Appl. No.: 10/633,106	Agent Docket: JS03-001
Amdt. Dated: 8/23/2005	Reply to Office action of 05/23/2005

Amendments to the Drawings:

REMARKS

Fig. 4

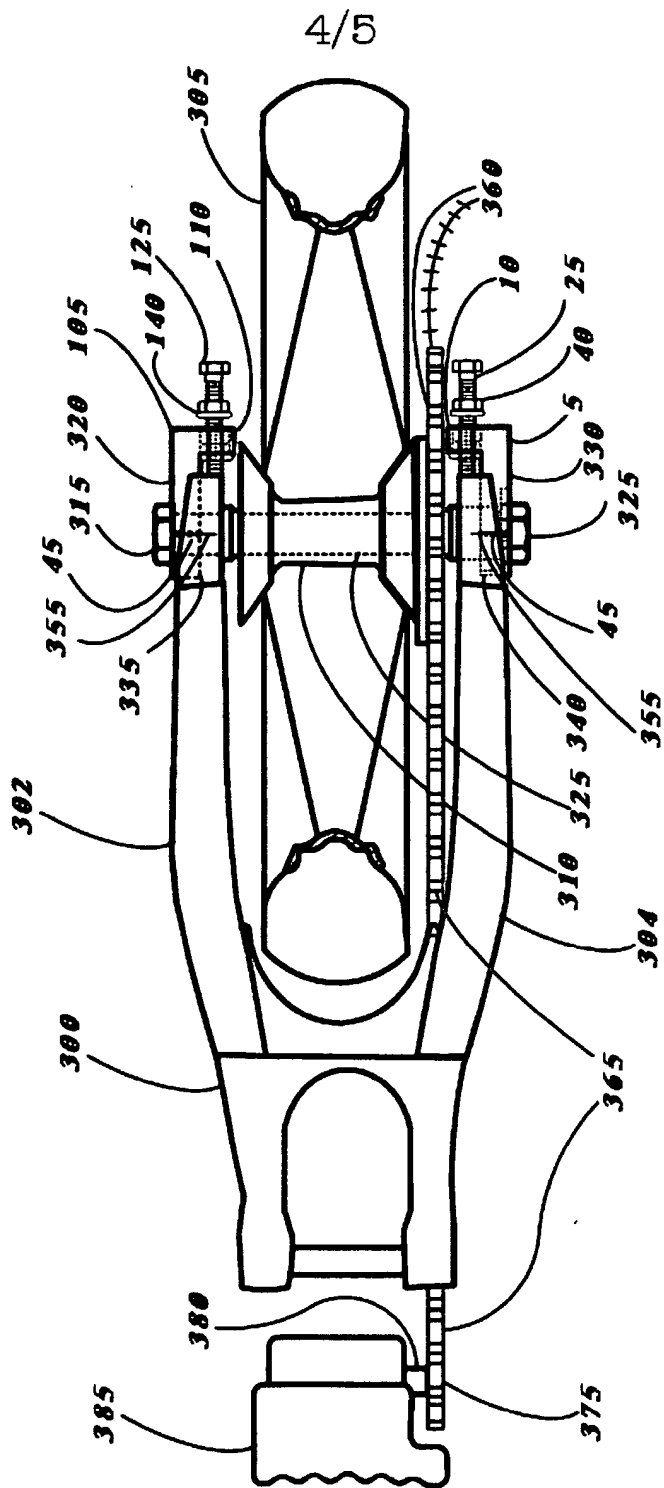
The attached sheets of drawings include changes to Figs. 4 and 5. These sheets, which include Figs. 4 and 5, replace the original sheets including Figs. 4 and 5. In Figs. 4 and 5, previously omitted elements chain **365**, drive sprocket
5 **375**, drive shaft **380**, and motor **385** has been added. No new matter is added.

Reconsideration to the objection to drawings under 37 CFR 1.83(a) is
5 requesting in light of the following arguments. Figs. 4 and 5 have been modified with the changes marked in red on the attached drawings to. Previously omitted elements chain **365**, drive sprocket **375**, drive shaft **380**, and motor **385** have been added to Figs 4 and 5. The flexible power transmission means of claims 1, 8-10, 15, 17-19, and 27-28 are the chain **365**. The elements drive sprocket **375**,
10 drive shaft **380**, and motor **385** are added for completeness and discussed in paragraphs [0002] and [0003] and added to paragraph [0046]. Approval of these changes is requested. No new matter has been added.

The specification has been amended to incorporate the numbering of the elements (chain **365**, drive sprocket **375**, drive shaft **380**, and the motor **385**
20 added to Figs. 4 and 5, but previously described within the specification. The
